RESOLUTION MEPC.261(68)
(adopted on 15 May 2015)

**AMENDMENTS TO THE 2014 GUIDELINES ON SURVEY AND CERTIFICATION
OF THE ENERGY EFFICIENCY DESIGN INDEX (EEDI)**
(RESOLUTION MEPC.254(67))

**AMENDMENTS TO THE 2014 GUIDELINES ON SURVEY AND CERTIFICATION
OF THE ENERGY EFFICIENCY DESIGN INDEX (EEDI)
(RESOLUTION MEPC.254(67))**

Figure 2: An example of scheme of conversion from trial condition to EEDI condition at EEDI power

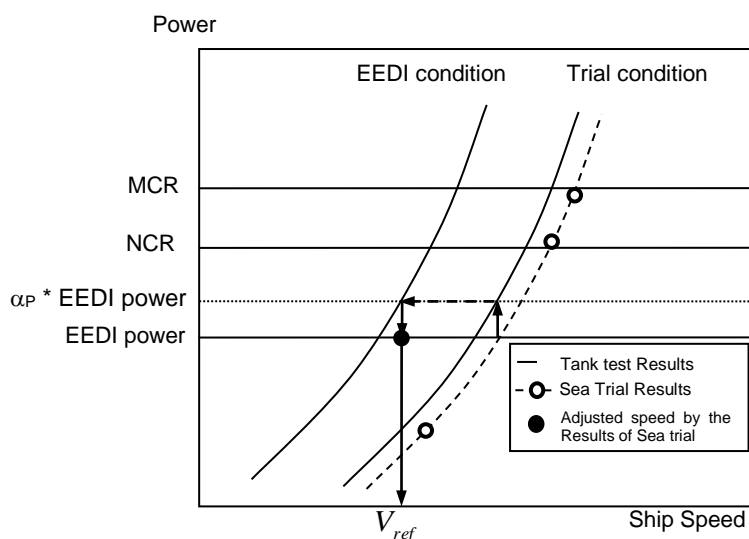
4.3.9 The submitter should compare the power curves obtained as a result of the sea trial and the estimated power curves at the design stage. In case differences are observed, the attained EEDI should be recalculated, as necessary, in accordance with the following:

- .2 for ships for which sea trial cannot be conducted under the condition as specified in paragraph 2.2 of the EEDI Calculation Guidelines: if the measured ship speed at the power of the main engine as specified in paragraph 2.5 of the EEDI Calculation Guidelines at the sea trial conditions is different from the expected ship speed on the power curve at the corresponding condition, the shipbuilder should recalculate the attained EEDI by adjusting ship speed under the condition as specified in paragraph 2.2 of the EEDI Calculation Guidelines by an appropriate correction method that is agreed by the verifier.

An example of scheme of conversion from trial condition to EEDI condition at EEDI power is given as follows:

V_{ref} is obtained from the results of the sea trials at trial condition using the speed-power curves predicted by the tank tests. The tank tests shall be carried out at both draughts: trial condition corresponding to that of the S/P trials and EEDI condition. For trial conditions the power ratio α_P between model test prediction and sea trial result is calculated for constant ship speed. Ship speed from model test prediction for EEDI condition at EEDI power multiplied with α_P is V_{ref} .

Figure 2 shows an example of scheme of the conversion to derive the resulting ship speed at EEDI condition (V_{ref}) at EEDI power.

Note: Further consideration would be necessary for speed adjustment methodology in paragraph 4.3.9.2 of these guidelines. One of the concerns relates to a possible situation where the power curve for sea trial condition is estimated in an excessively conservative manner (i.e. power curve is shifted in a leftward direction) with the intention to get an upward adjustment of the ship speed by making the measured ship speed at sea trial easily exceed the lower-estimated speed for sea trial condition at design stage."
